Montgomery County Intercounty Connector

Montgomery Auto Sales Park (8-06001 & 8-06002)

This office has reviewed the Site Plan (8-06001 and 8-06002) for the Montgomery Auto Sales Park dated June 2004. The 14.77 acres Montgomery Auto Sales Park Property is located south of Briggs Chaney Road and east of US 29. The Site Plan shows the proposed reconstruction of two existing buildings as well as changes to the existing parking lot.

Montgomery Auto Sales Park

SOURCE: MARYLAND SHA (JAN 2006)

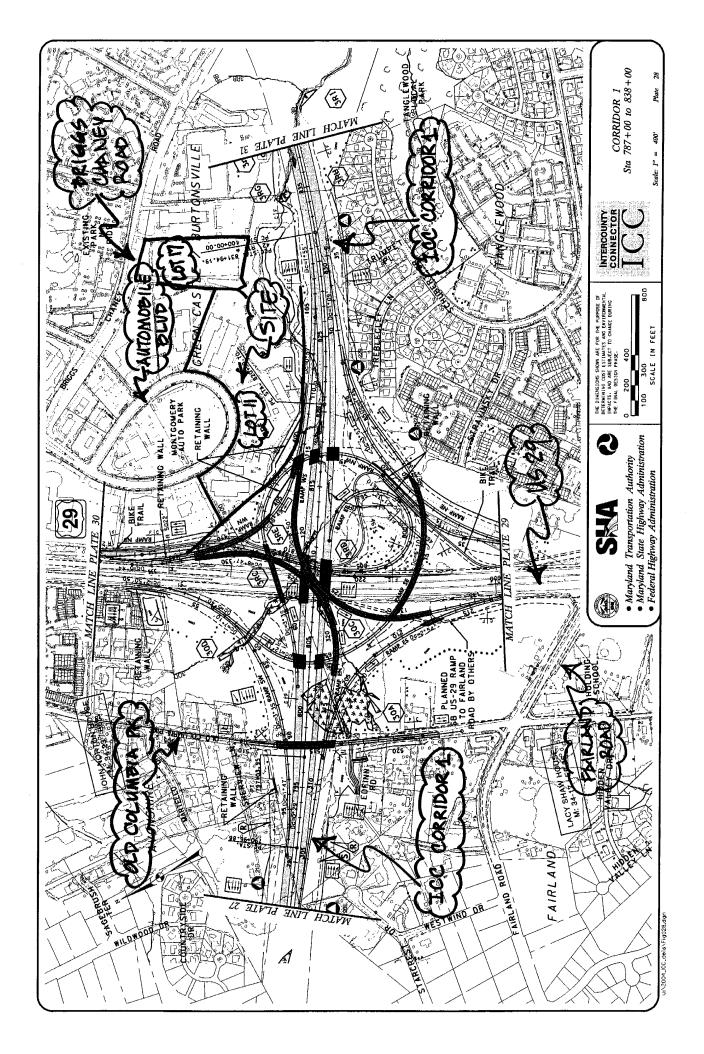
The Intercounty Connector (ICC) Corridor One, as shown to date, impacts about 0.80 acres of the property, as shown on the attached map. About 0.29 acres of this impact (highlighted in purple on the attached map), located right station 48+50 to right station 50+55 along ramp "NW", is due only to grading for supporting slopes, and could be handled as an easement. The remaining 0.51 acres of impact (highlighted in orange on the attached map) contains a potential retaining wall, and needs to be acquired as right-of-way.

To protect property that will support the State Highway Administration/Maryland Transportation Authority (SHA/MdTA) locally preferred alternative, Corridor One, which is being studied as part of the current National Environmental Policy Act process for the project, we request that your agency require reservation of this property through the project's Record of Decision scheduled for release on April 1, 2006. In addition, we request that the Site Plan approval be made contingent upon the owner continuing to work with the SHA regarding grading and drainage to make certain that neither the owner's or SHA's interests are precluded by the other.
